SR 105/US 441 Business
Interchange Widening Improvements
STP-2640(10), P.I. 132100
Habersham County, Georgia

Value Engineering Study Report
Preliminary Design Stage

January 2008

ALTERNATIVE NO.: **EE-2**
 SHEET NO.: **8** of **11**

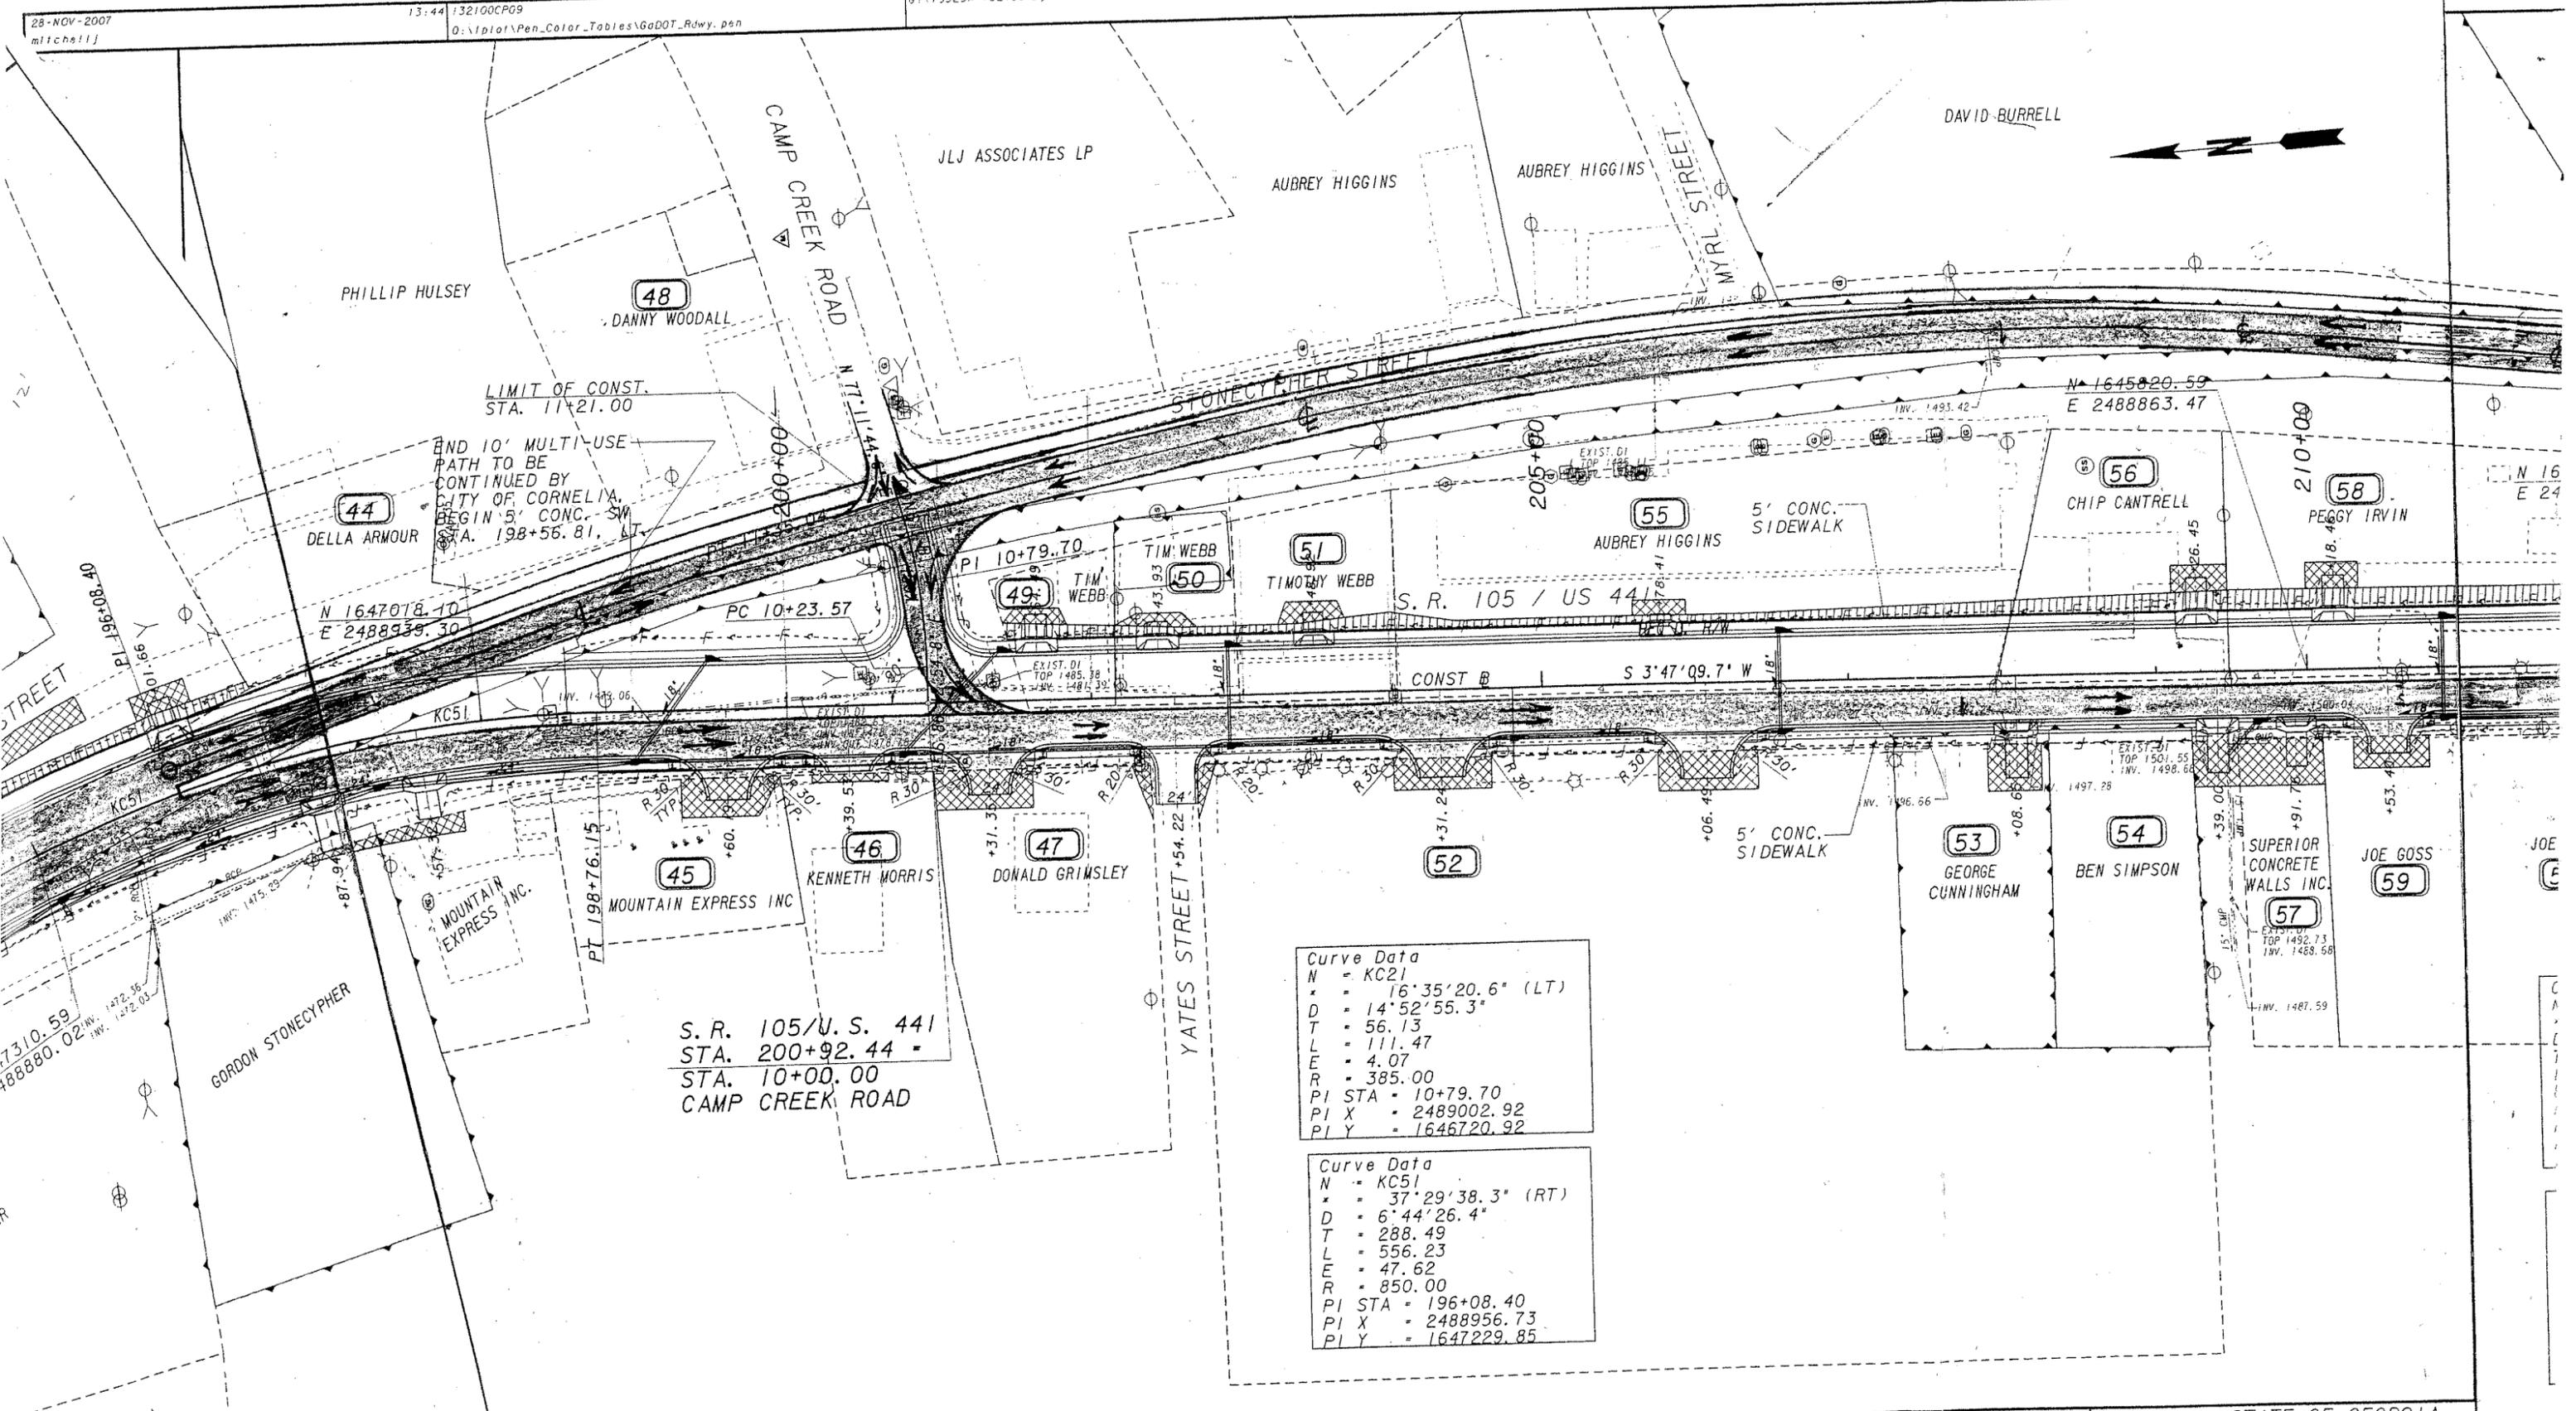
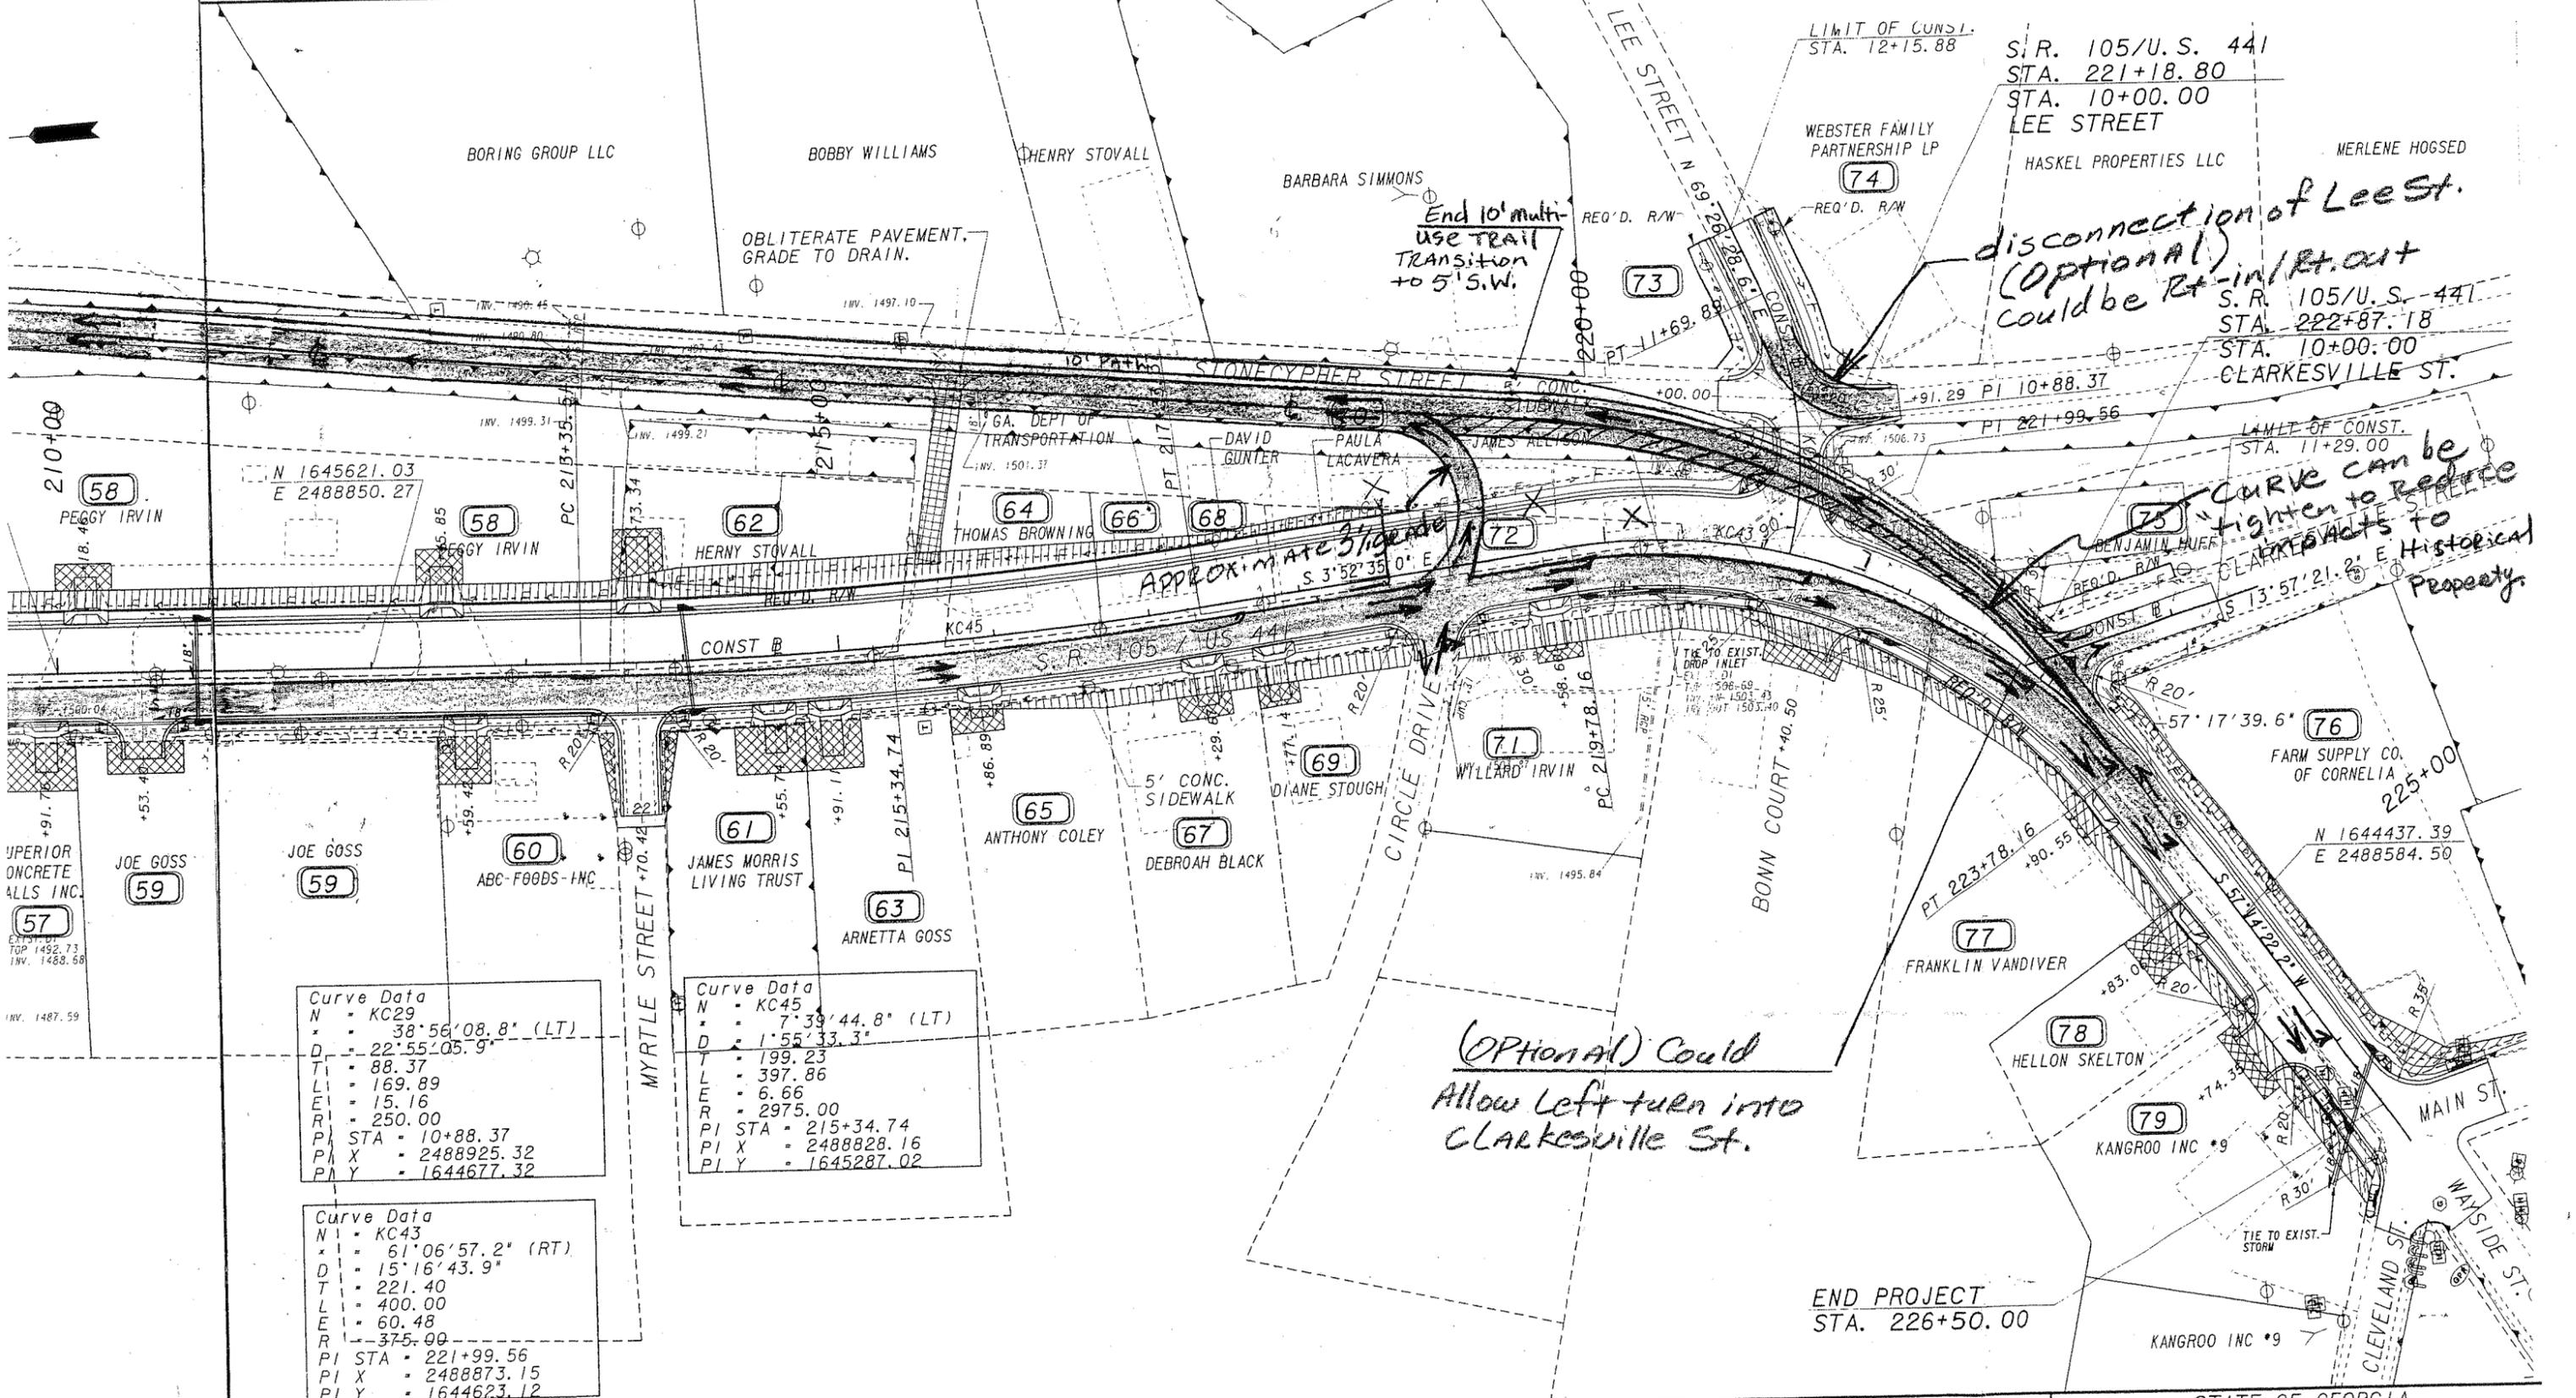
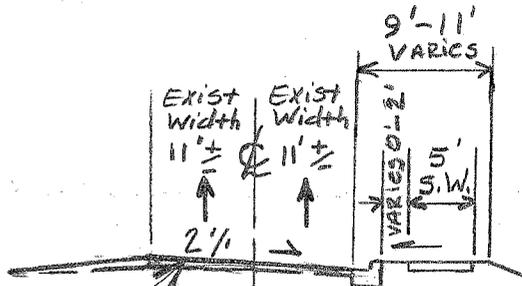
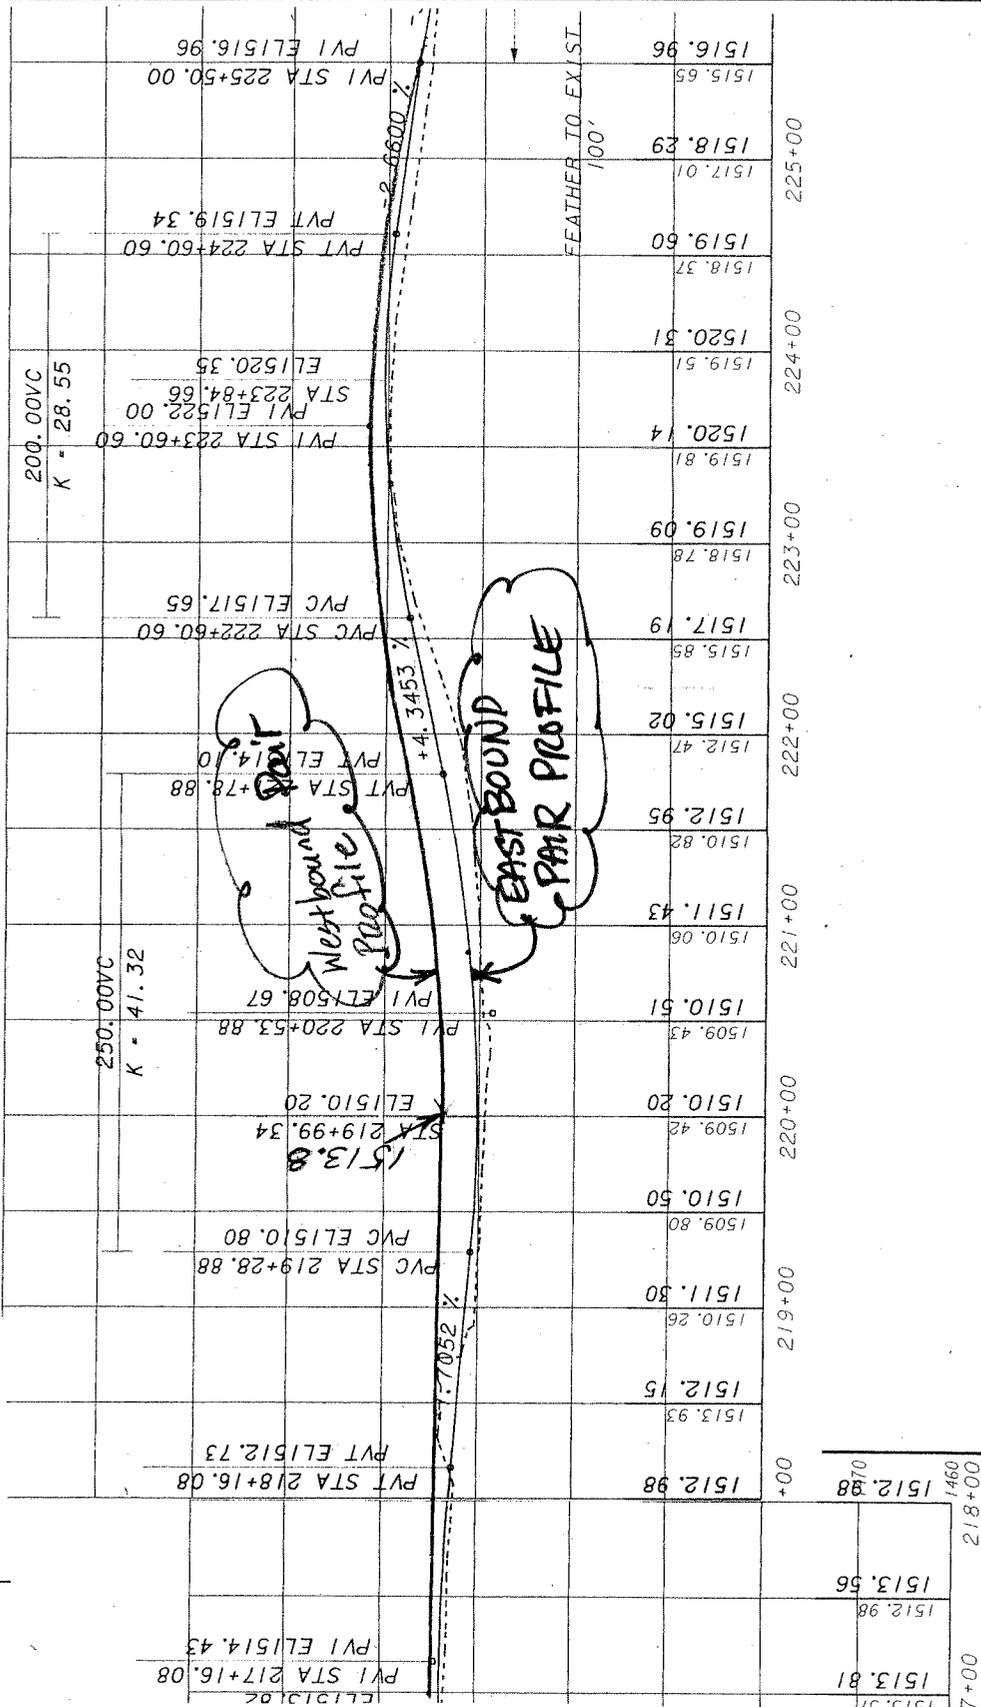
The westbound side of the one-way pair would be placed within Stonecypher Street right of way utilizing a pavement section consisting of 12-ft. and 11-ft. lanes, as in the current design. The multi-use trail would be placed at the north side of the westbound pair. The roadway would drain towards the median. The south side would be graded out at 4:1 and retain a rural type section. A good portion of the abandoned railroad track bed would be retained as drainage and to preserve history. Note: the westbound pair alignment in the vicinity of Clarkesville Street can be modified to miss the historical property at the same location.

The key benefits of this alternative are improved operations of SR 105, reduced driveway/SR 105 mainline collision potential and reduction in right of way impacts (including the historical property). This alternative requires that an additional 2400 linear feet of multi-use trail not in the current design (a value of approximately \$50,000) be constructed in the state highway, which would be a benefit to the city of Cornelia. The key disadvantage, assuming the technical operations of the roadway system are resolved, is the change of access along the one-way pairs. This disadvantage could be sold to the city of Cornelia by suggesting that the one-way pair allows more properties along the one-way pair to be commercialized.
